HISTORIC LANDMARK COMMISSION PERMITS IN NATIONAL REGISTER HISTORIC DISTRICTS APRIL 24, 2017 NRD-2017-0012

721 Congress Avenue Congress Avenue Historic District

PROPOSAL

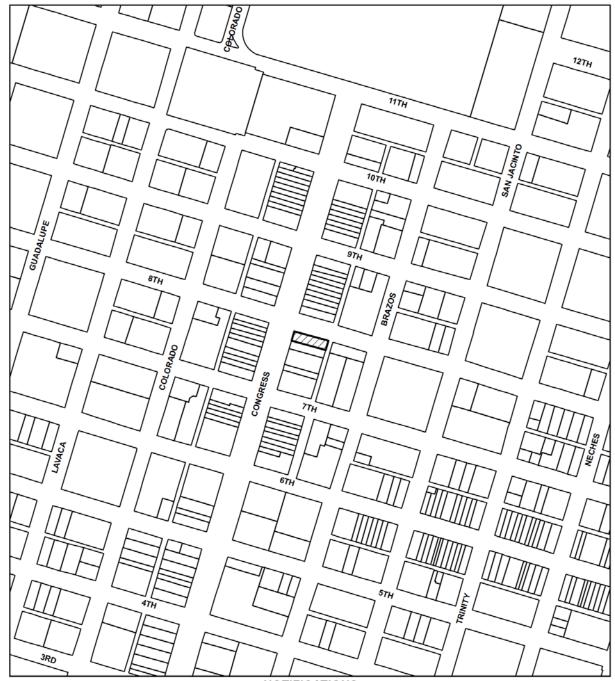
Other new high-rise projects on Congress Avenue have taken the rhythm of the street into greater account than this project seems to do. The new hotel at 7th Street and Congress Avenue has a greater articulation of the three-bay rhythm of the street within the 23-foot wide facades common on the avenue.

While recognizing the high quality and innovation in the design and materials of this building, staff must disagree with its compatibility in the historic district. Congress Avenue is noted for its rhythm of three bays at the street level, and this is the pattern that new construction should reference for compatibility. The street-level presence of this building appears monolithic in comparison in its height, choice of material, and set-back from the flush line of the street. There does not appear to be sufficient reference to the typical bay width, and the printed glass, while innovative, delivers the impression of a sheer 3-story wall without the undulation and piercings typical of the historic patterns along the avenue. Staff therefore recommends that the applicants consider a modification to the street-level façade on Congress Avenue that lessens the impact of the monolithic aspect of the entry and reflects greater compatibility with the traditional bay divisions and patterns in the historic district. A building of this size should do its best to blend in, rather than stand apart from the contributing buildings in the historic district, at least on its street level.
